# UNITED STATES PATENT AND TRADEMARK OFFICE

APPLICATION NO.	FILING DATE	FIRST NAMED INVENTOR	ATTORNEY DOCKET NO.	CONFIRMATION NO.
10/659,145	09/10/2003	Marie Ann McMasters	GE126465	3043
29827	7590	01/24/2005	EXAMINER	
FRANCIS L. CONTE, ESQ. 6 PURITAN AVENUE SWAMPSCOTT, MA 01907			KIM, TAE JUN	
			ART UNIT	PAPER NUMBER
			3746

<b>Office Action Summary</b>	<b>Application No.</b> 10/659,145	<b>Applicant(s)</b> MCMASTERS, MARIE ANN	
	<b>Examiner</b> Ted Kim	<b>Art Unit</b> 3746

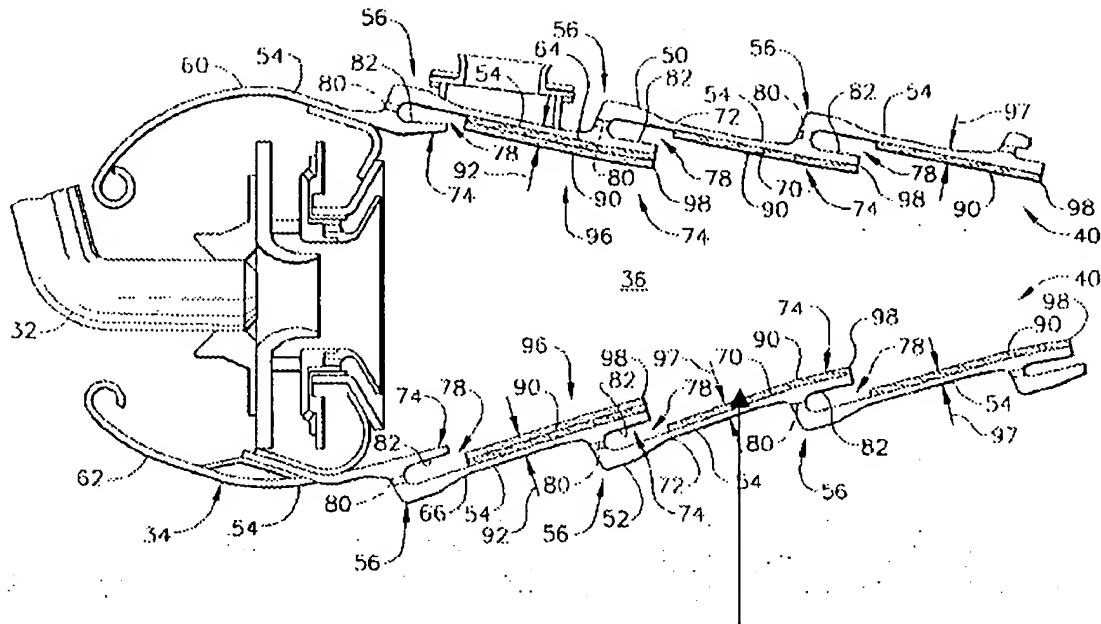
3. Claims 1-4, 11-13 are rejected under 35 U.S.C. 102(b) as being anticipated by McCaffrey et al (6,438,958). McCaffrey et al teach a combustor liner comprising: a plurality of forward 64 and aft 66 panels 54 joined together at a cooling nugget 56 including an integral bridge having a lip 74 extending aft from said forward panel and spaced from said aft panel to define a slot 78 terminating in an outlet; a thermal barrier coating 96 with thickness  $T_1$  covering inboard surfaces of said panels and lip with a nominal thickness  $T_1$ ; and said lip having a distal end at said slot outlet being spaced from said coating aft of said slot less than about said coating nominal thickness; wherein said slot has a height at said slot outlet, and said coating is as thick as about half said slot height (the range for the thickness  $T_1$  can be varied to about this ratio); wherein said lip has a thickness at said slot outlet, and said coating is thicker than said lip thickness; said cooling nugget includes a row of aperture inlets 80 disposed in flow communication with said slot for channeling cooling air therethrough; and said nugget inlets have a smaller collective flow area relative to said slot outlet at said coating.

increase illustrated TBC thickness  
to be same as the first panel

McCaffrey et al teach that layer 90, 96 can be applied to all the panels 54 with the same thickness  $T_1$  and when that is met, the said lip having a distal end at said slot outlet is spaced from said coating aft of said slot less than about said coating nominal thickness
